Model: Z-C2		Date: 30-May-14	No.: RD791001
Subject: Service manual correction (Fax option)		Prepared by: K.Kunimatsu	
From: 1st Tech Service Sect., MFP/P Tech Service Dept.			
Classification:	<input type="checkbox"/> Troubleshooting <input type="checkbox"/> Mechanical <input type="checkbox"/> Paper path <input type="checkbox"/> Product Safety	<input type="checkbox"/> Part information <input type="checkbox"/> Electrical <input type="checkbox"/> Transmit/receive <input type="checkbox"/> Other ()	<input type="checkbox"/> Action required <input checked="" type="checkbox"/> Service manual revision <input type="checkbox"/> Retrofit information <input type="checkbox"/> Tier 2

Service Manual Revision

The Installation Procedure was corrected as follows.

Fax option

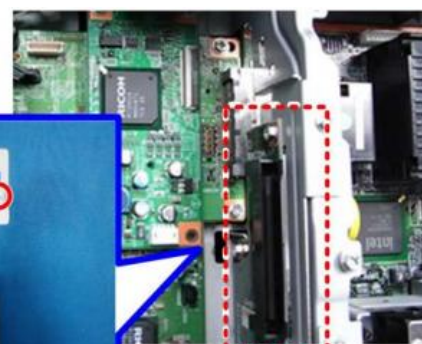
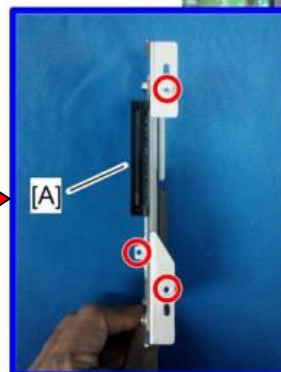
Incorrect

d791b0005

d483i518

Correct

10. Fasten the relay board [A] (⚙️x2). **3**

- Make sure that the FCU is seated correctly. If not, SC672 occurs.

24. Connect the modular harnesses to the FCU (🔌x2).

- [A] 2-pin connector
- [B] 3-pin connector

For NA

- [A] 2-pin connector
- [B] 3-pin connector

For EU

- [A] 6-pin connector
- [B] 6-pin connector
